CALL NO. 101
CONTRACT ID NO. 211009
ADDENDUM # 2

Subject: Butler County, NHPP 0031 (016)
Letting March 19, 2021

- (1) Revised - Proposal Bid Items - Pages 116-120 of 120
- (2) Revised - Plan Sheets - R2, R2B, R2D, R2E, R2G, and S1

U.S. 231 OVER KY 9007 (NATCHER PKWY)

COUNTY OF	ITEM NO.	SHEET NO.
BUTLER	3-2042.30	R2

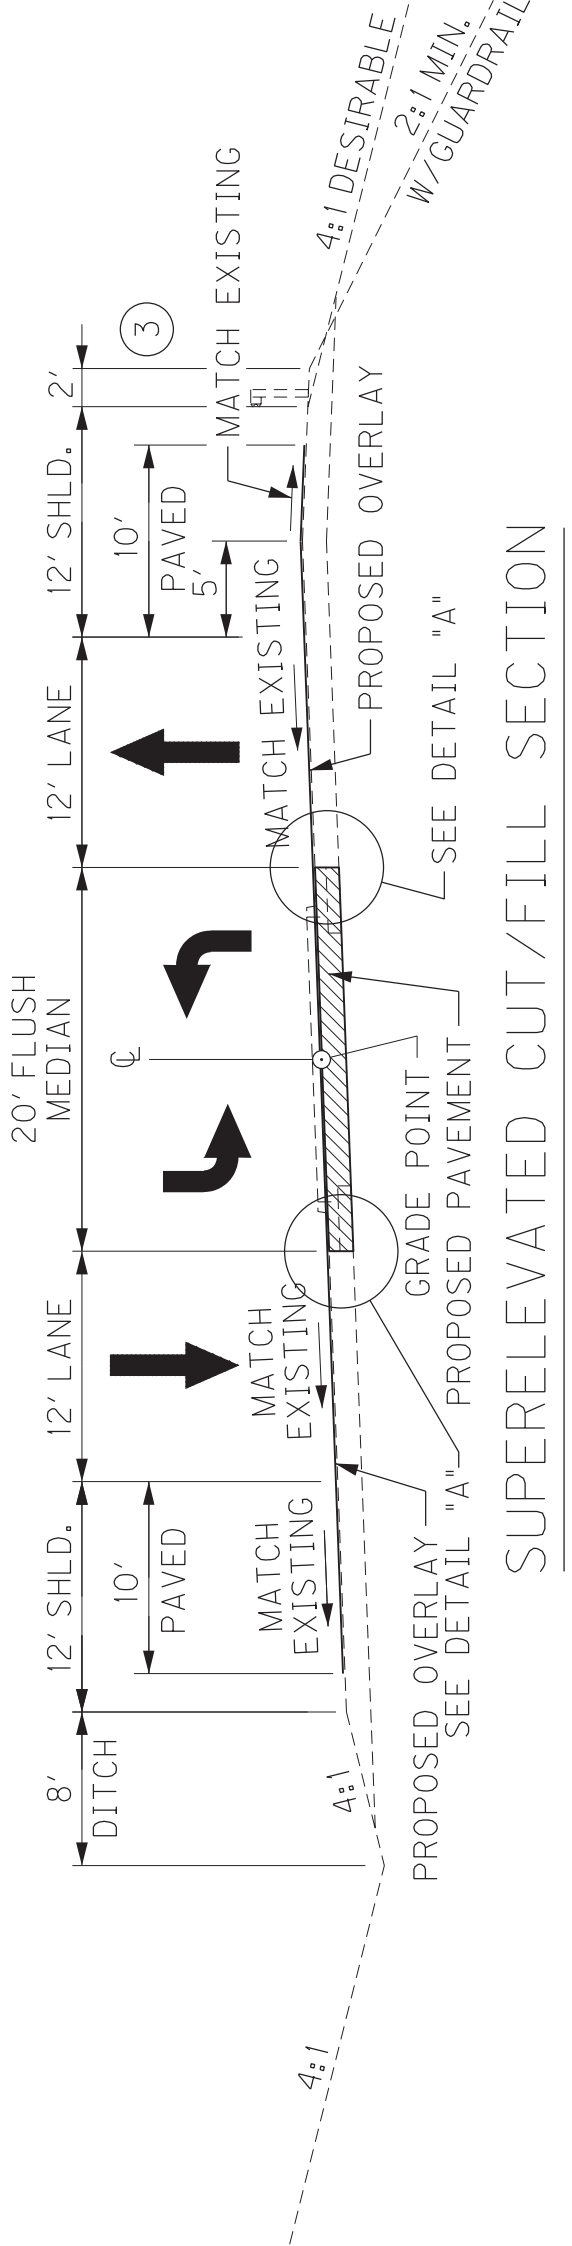
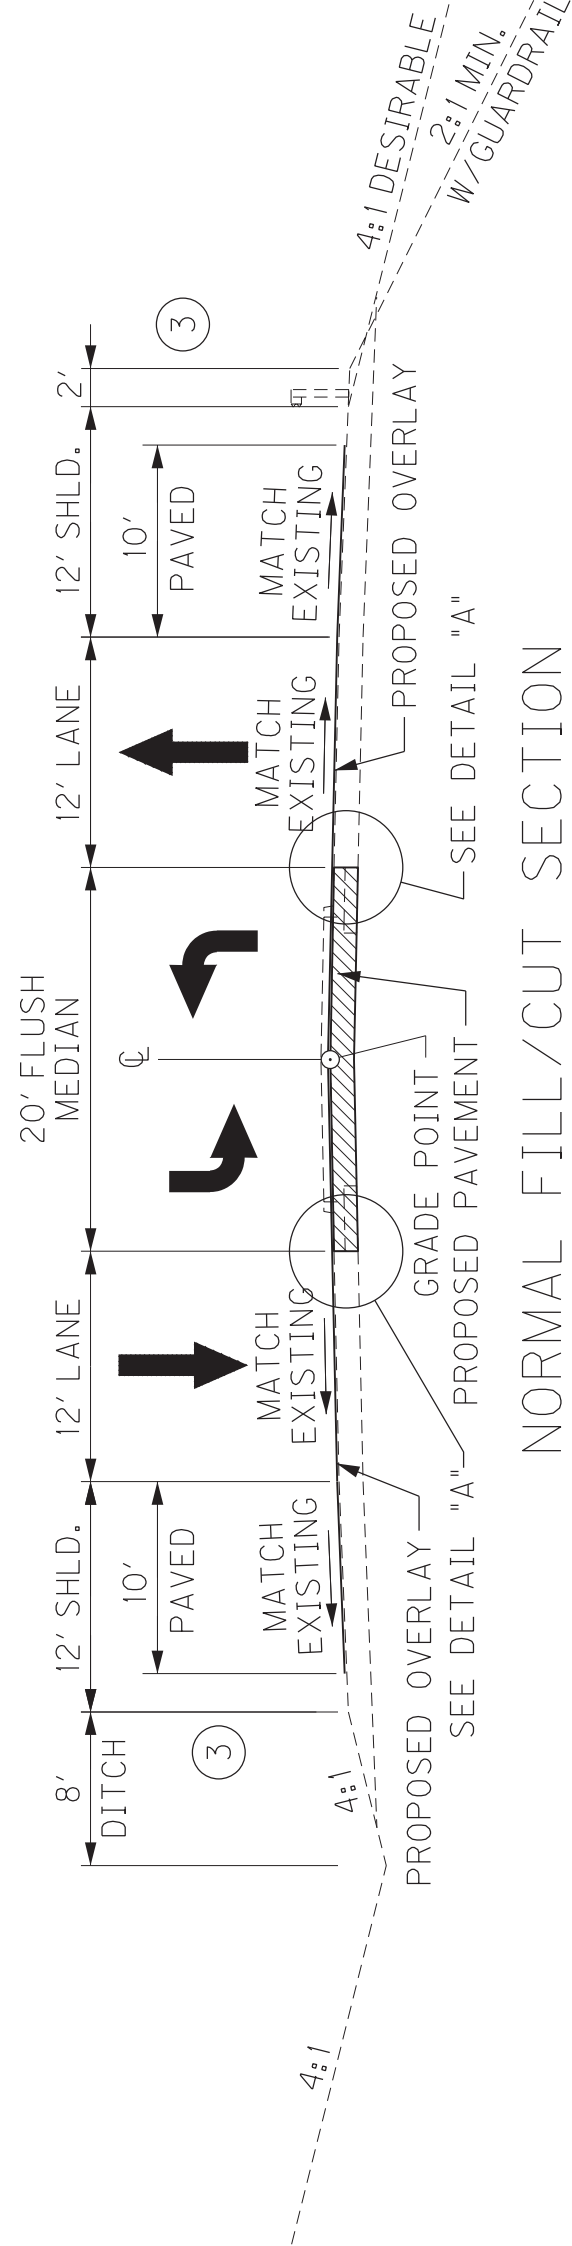
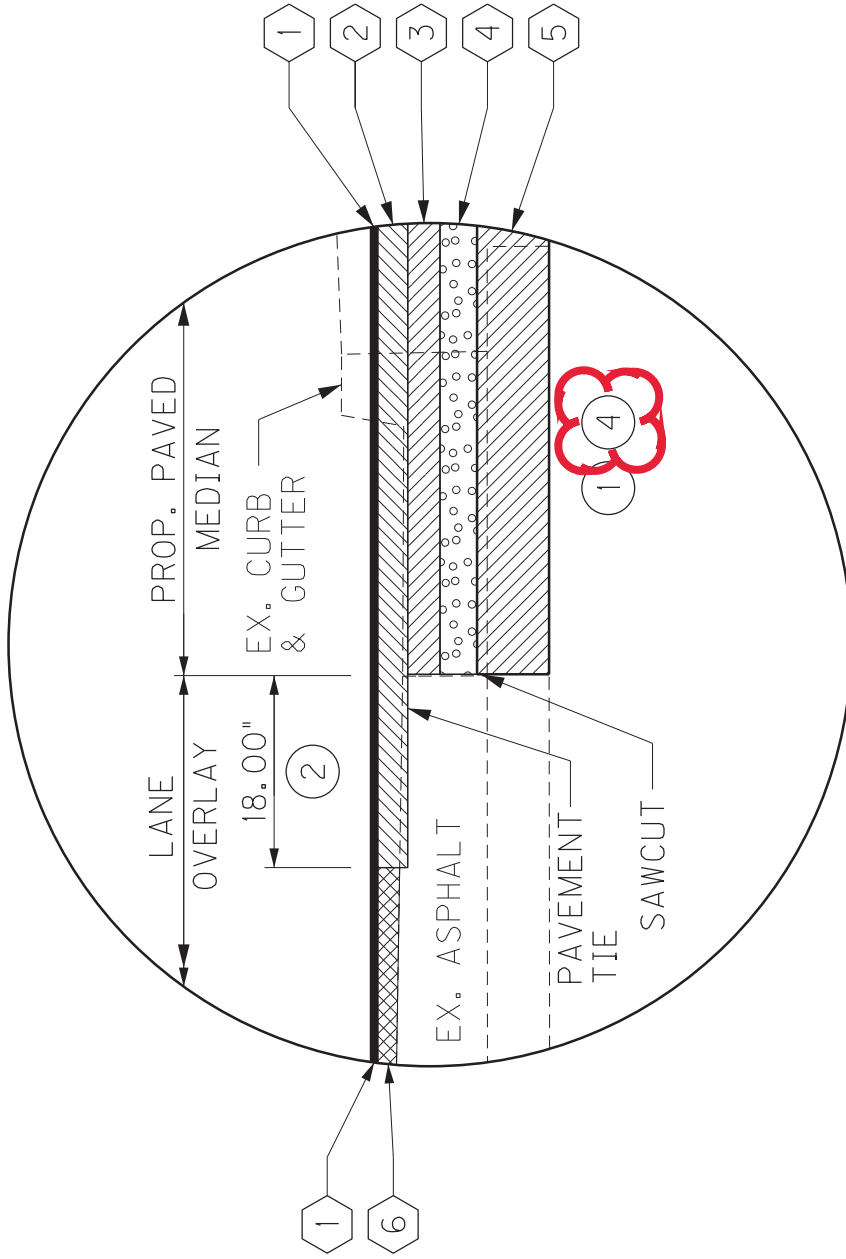
REVISED 3-11-2021

COUNTY OF	ITEM NO.	SHEET NO.
BUTLER	3-2042.30	R2B

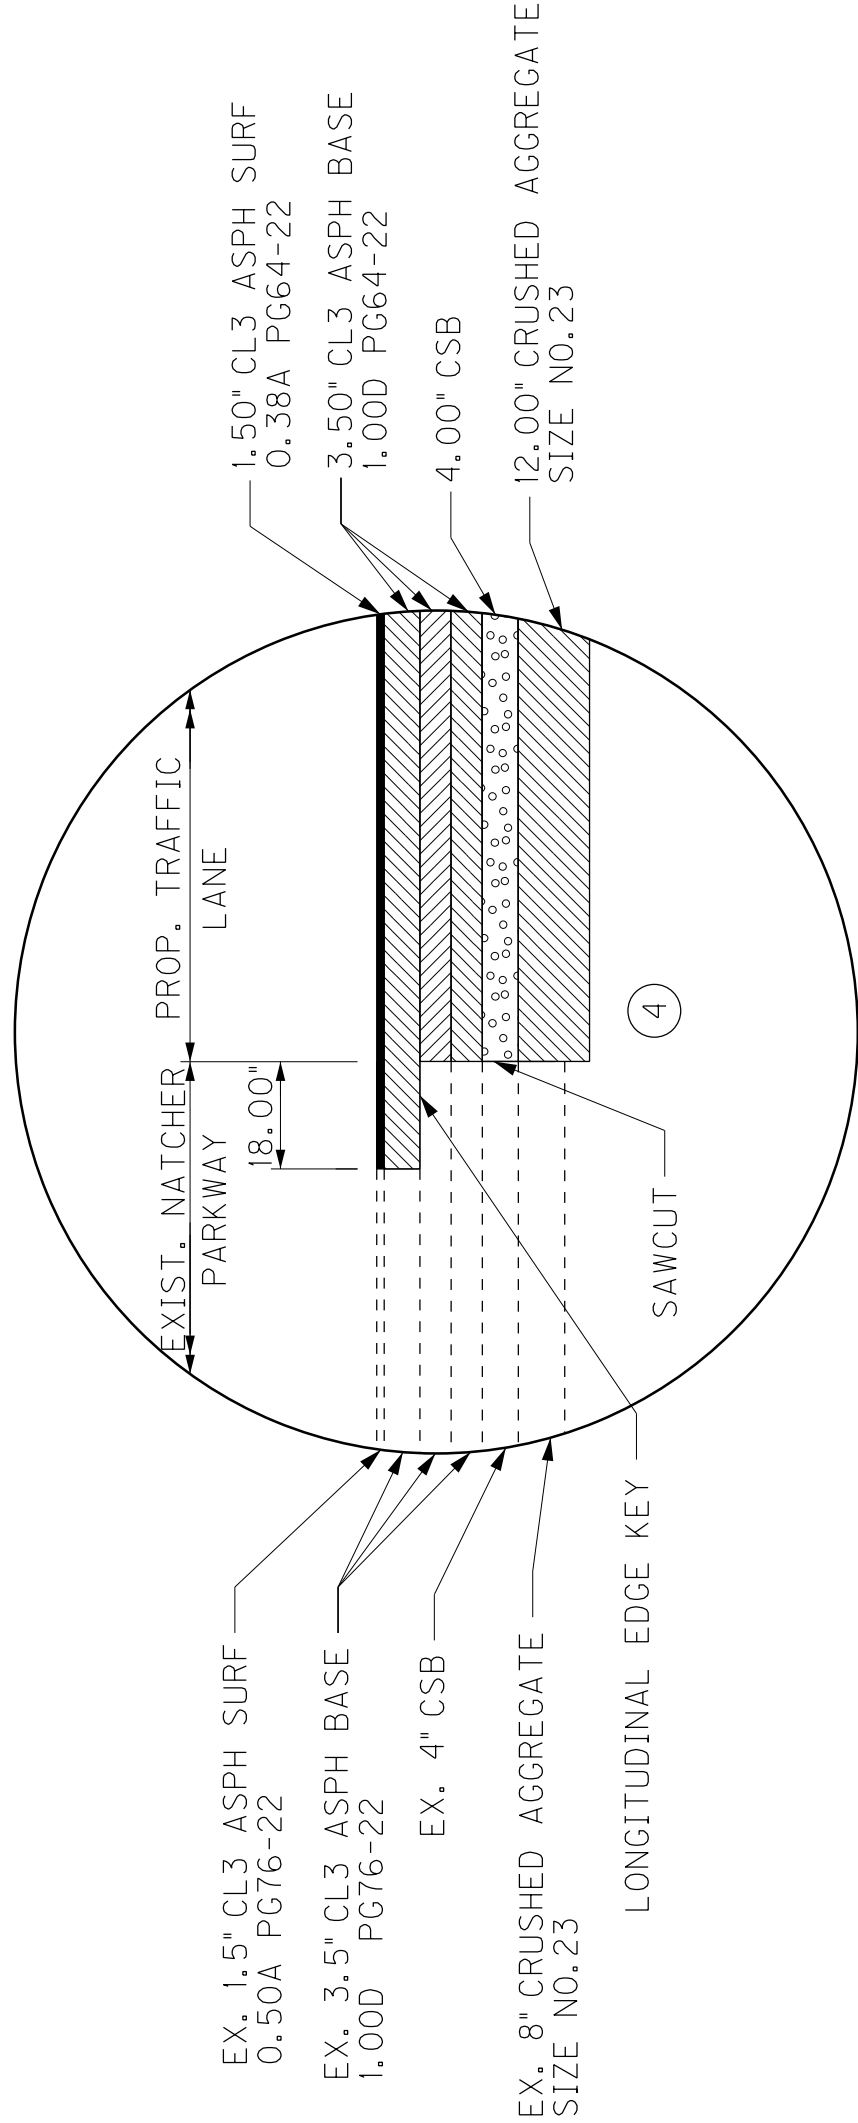
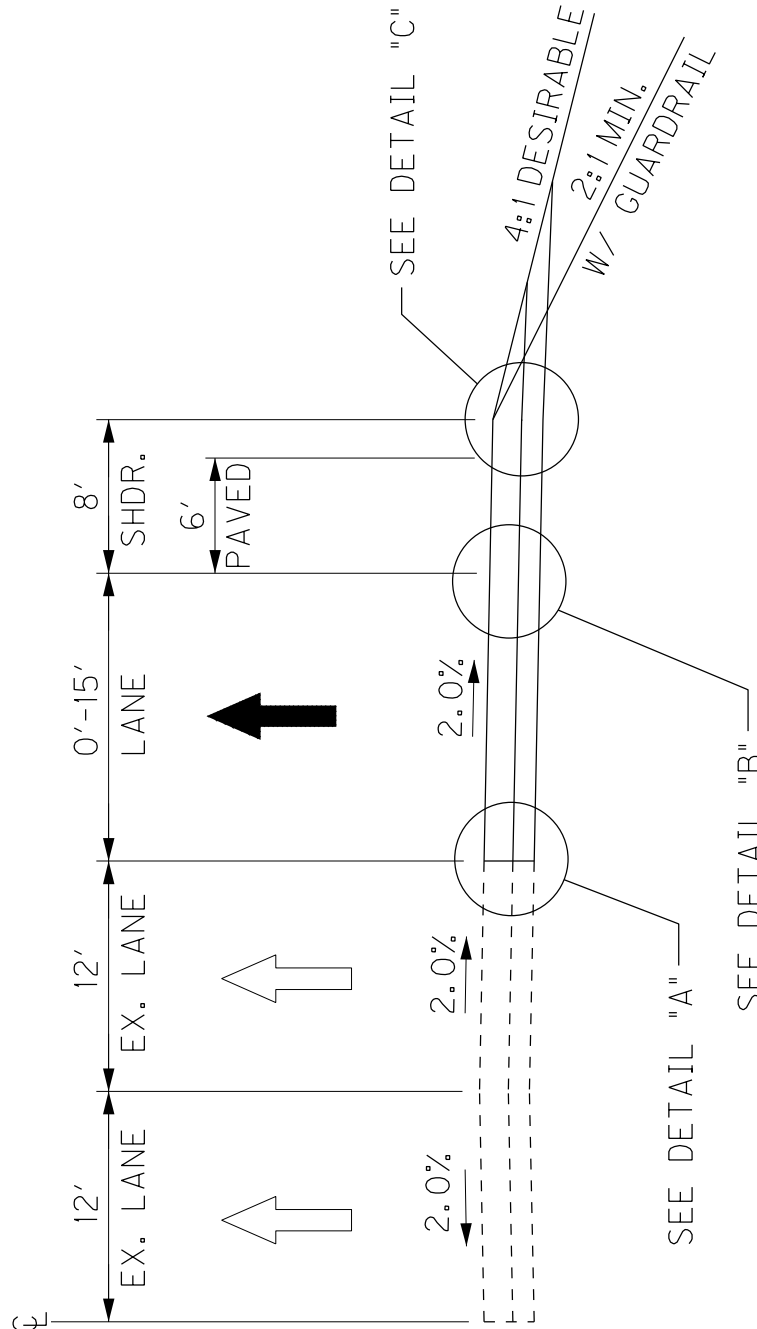
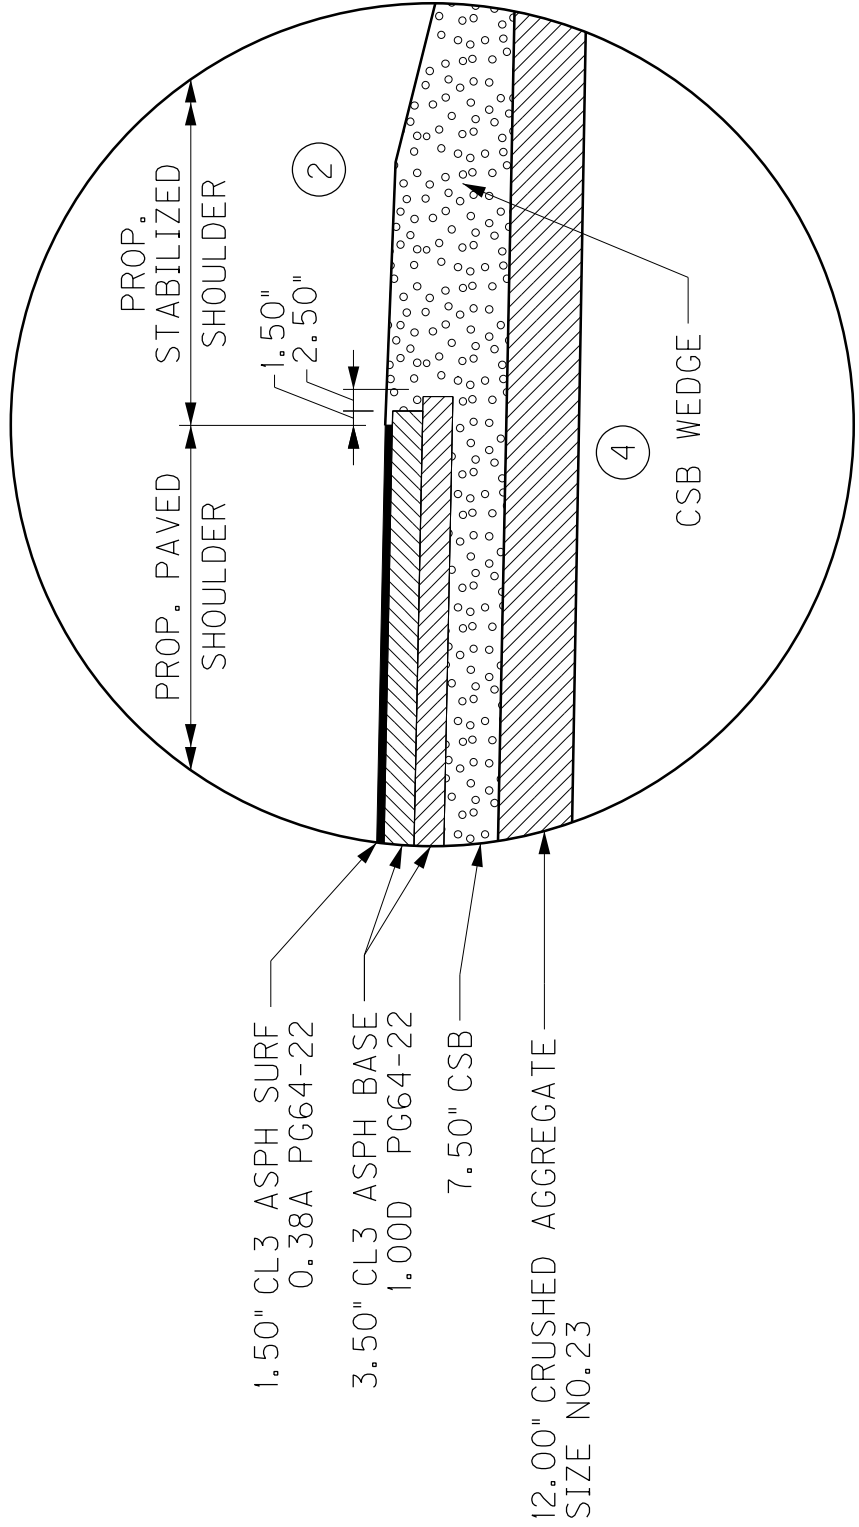
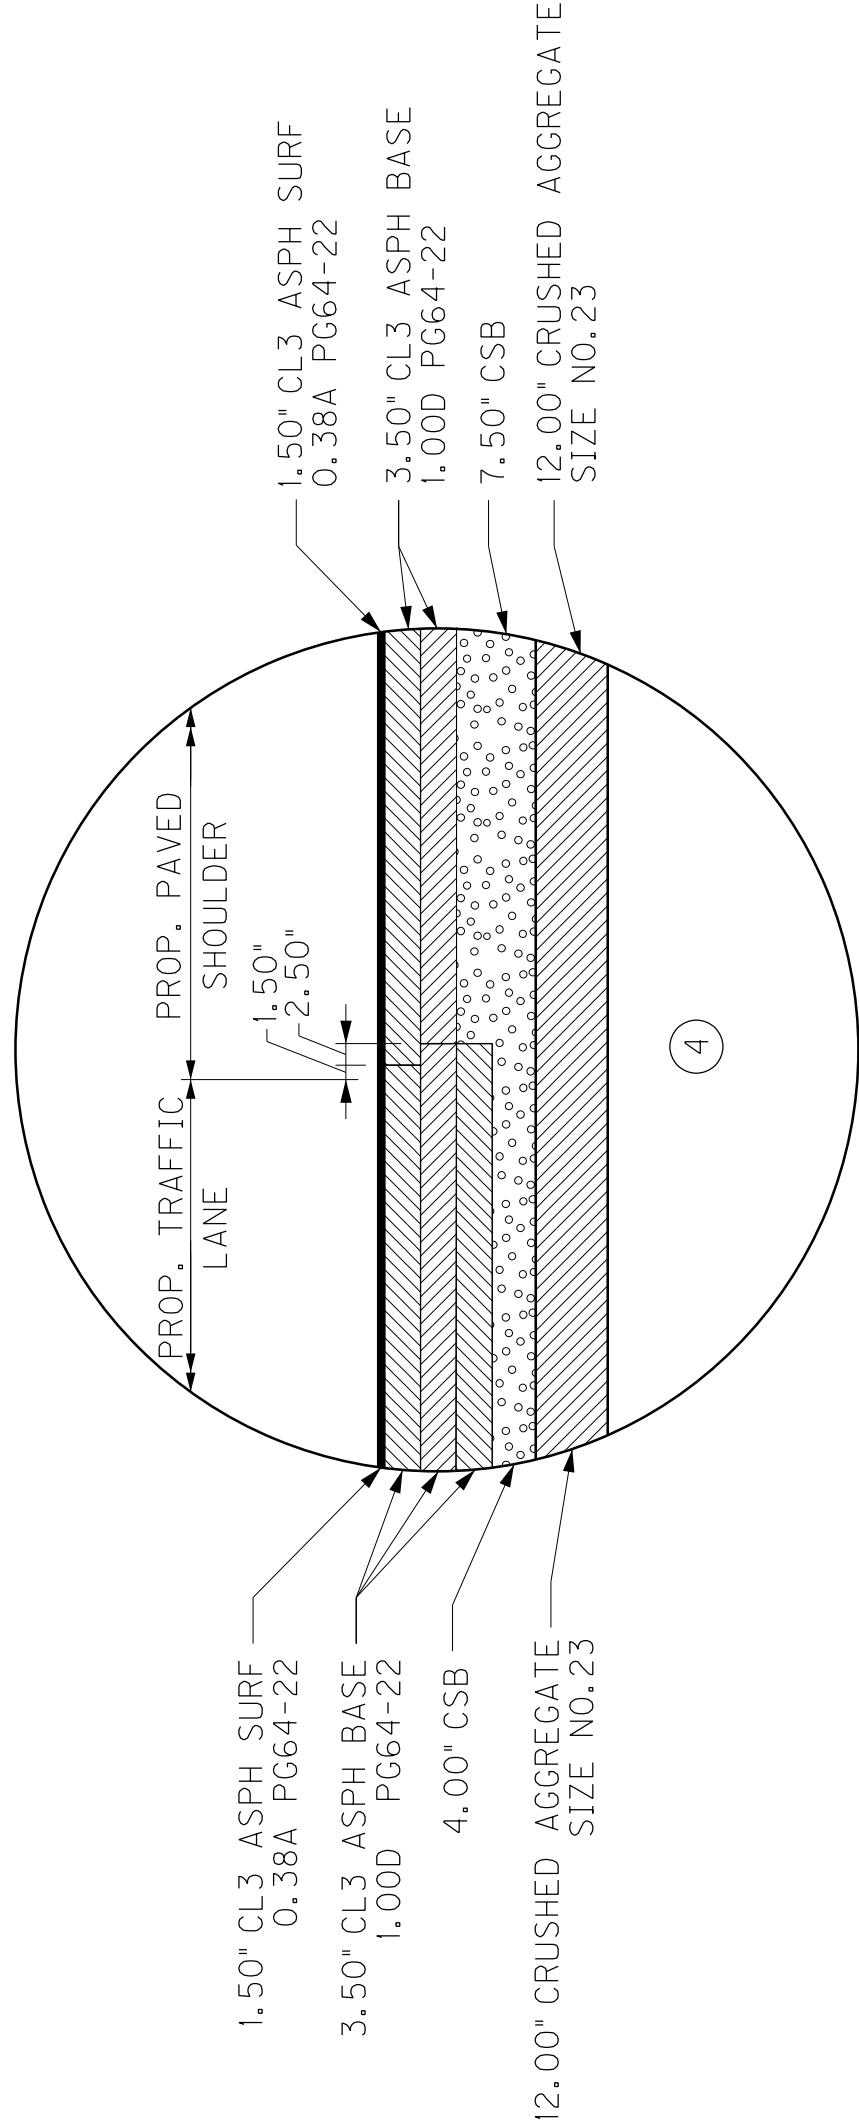
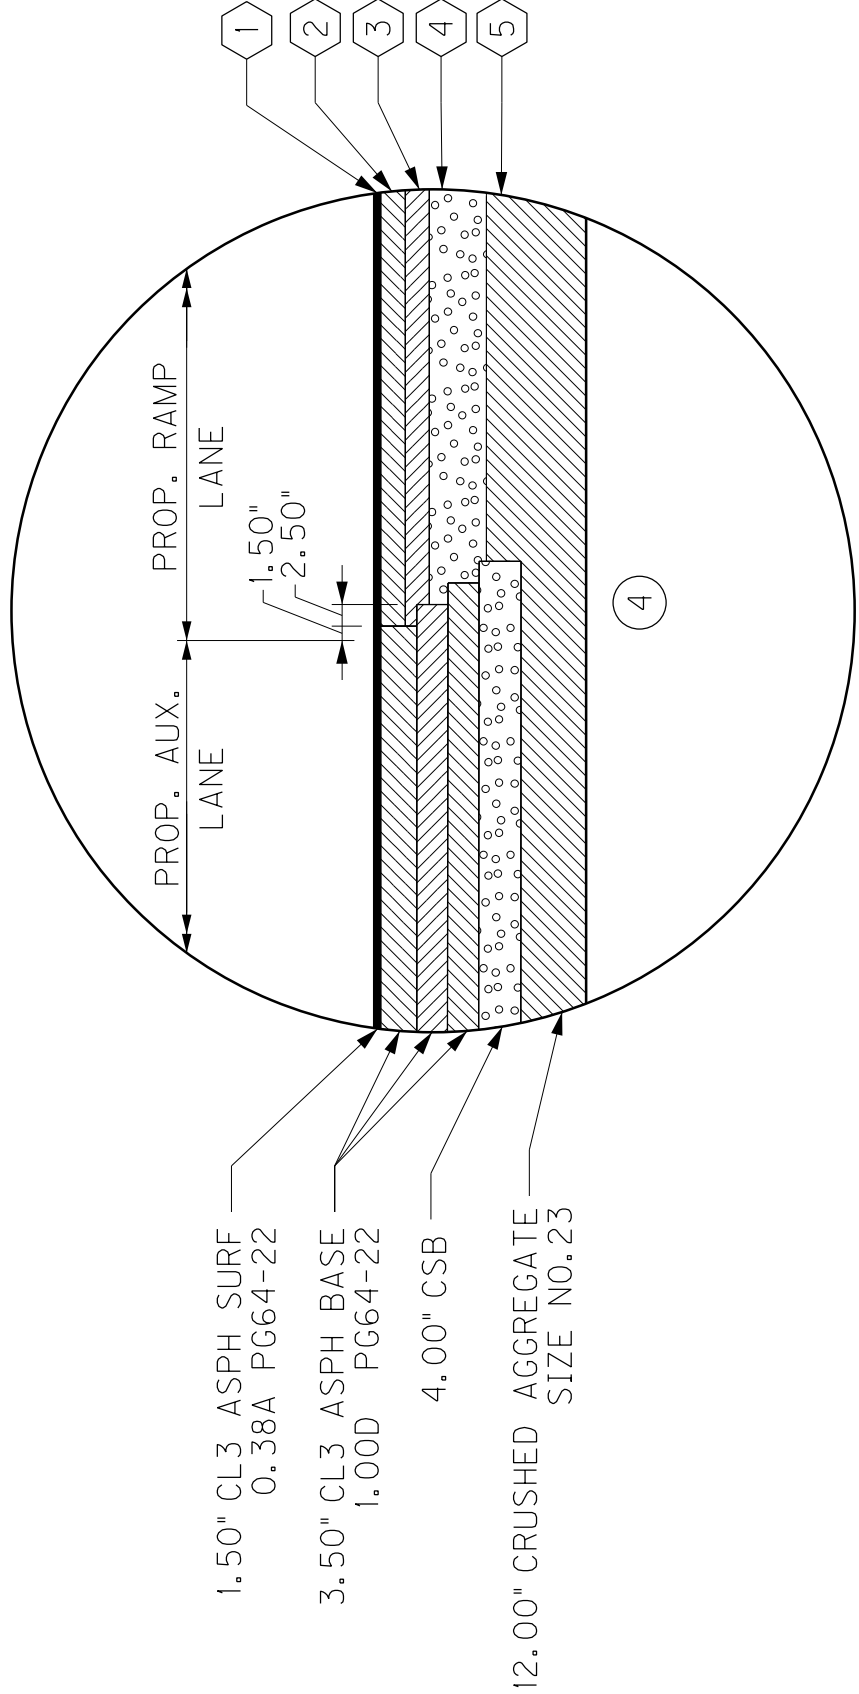
REVISED 3-11-2021
